**MODIFICATION SHEET NO. RDSO/2013/EL/MS/0426, (Rev.'0'), Dated 18.07.13.**

Modification Sheet of Bogie isolation rotary switch (Sch. Pos. 154 cut out switch) in three phase electric locomotives.

Fig.1

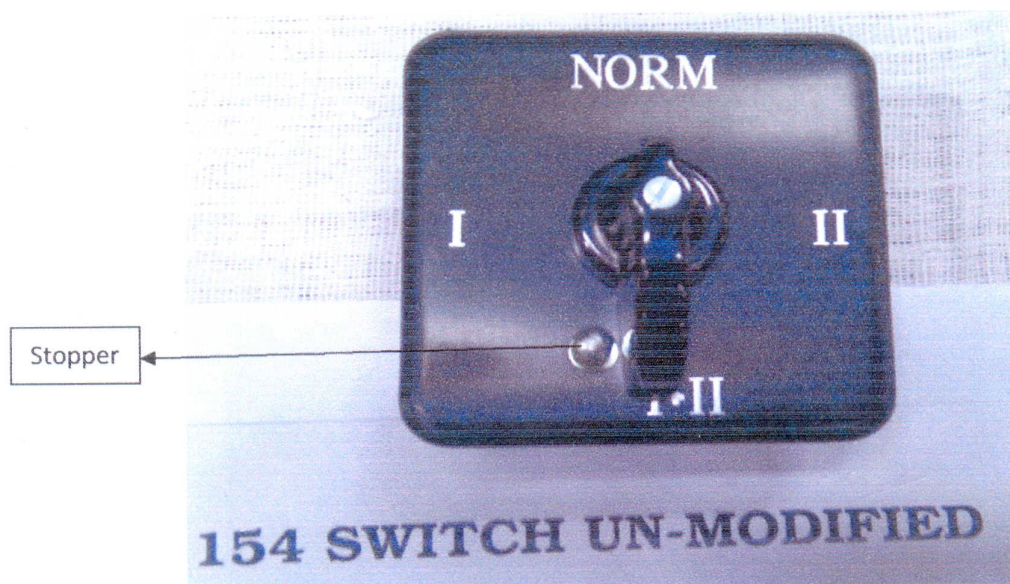
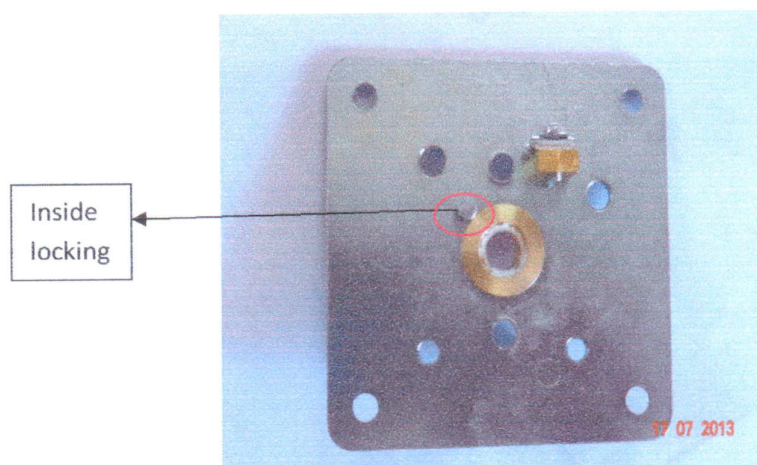
For isolating bogie-II, cut out switch 154 is to be put first in bogie-I cut out position, then bogie-I&II position and then the bogie-II cut out position. This is because a stopper is provided on the surface of the switch to prevent the rotation in clockwise direction (shown in Annexure-I, Fig.1) and the locking provided inside the switch (shown in Annexure-I, Fig.2). In the process of sequential operation, if the Loco Pilots keeps the cut out switch either in bogie-I or bogie-I&II position for more than 10 seconds bogie-I or both bogies get isolated. To bring back the isolated bogie, the driver has to switch OFF/ON MCE, failing which, subsequent operation for isolation of bogie-II by keeping the switch in bogie-II position will result in main power off. Once main power off is noticed, LP fails the loco. Even if they do trouble shoots considerable time is lost in proper isolation of bogie.

Fig.1

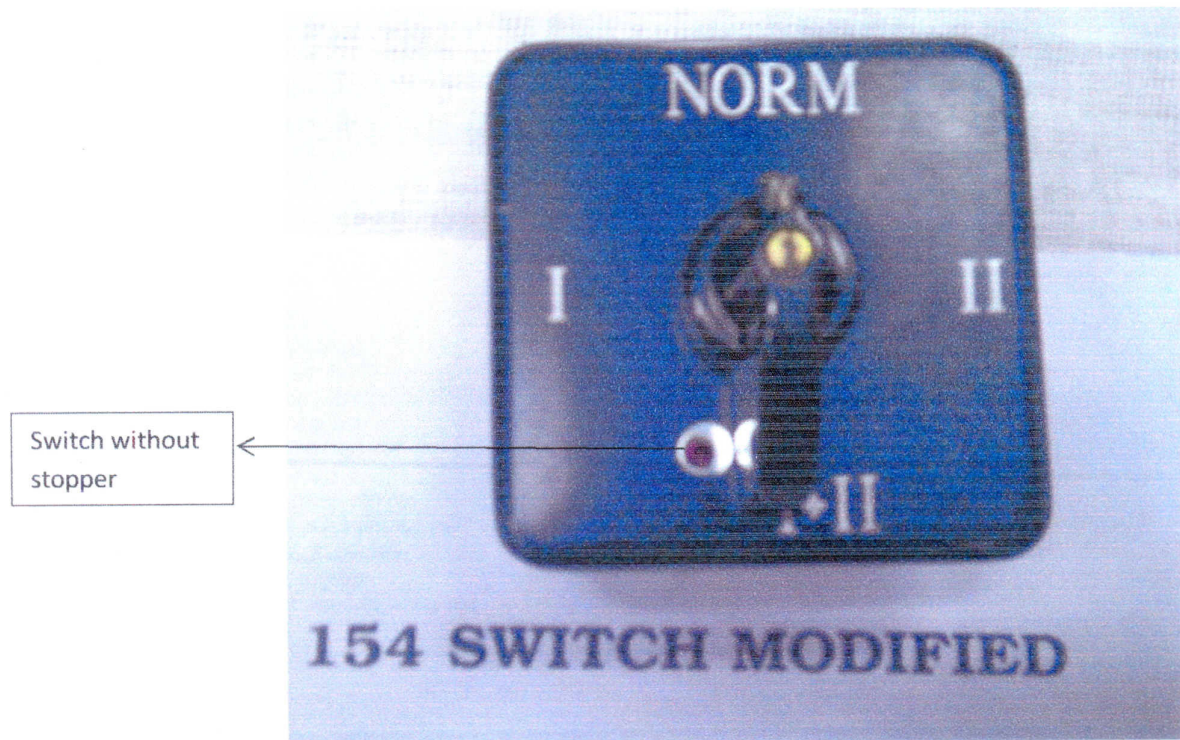
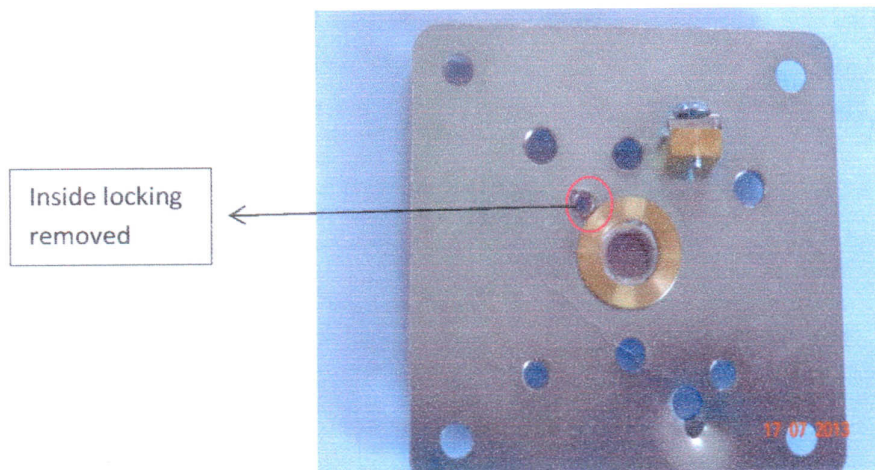
To overcome the problem, the stopper provided on the surface of the switch, which prevent the rotation in clockwise direction and the locking provided inside the switch need to be removed (shown in Annexure-II, Fig.1 & Fig.2) respectively.
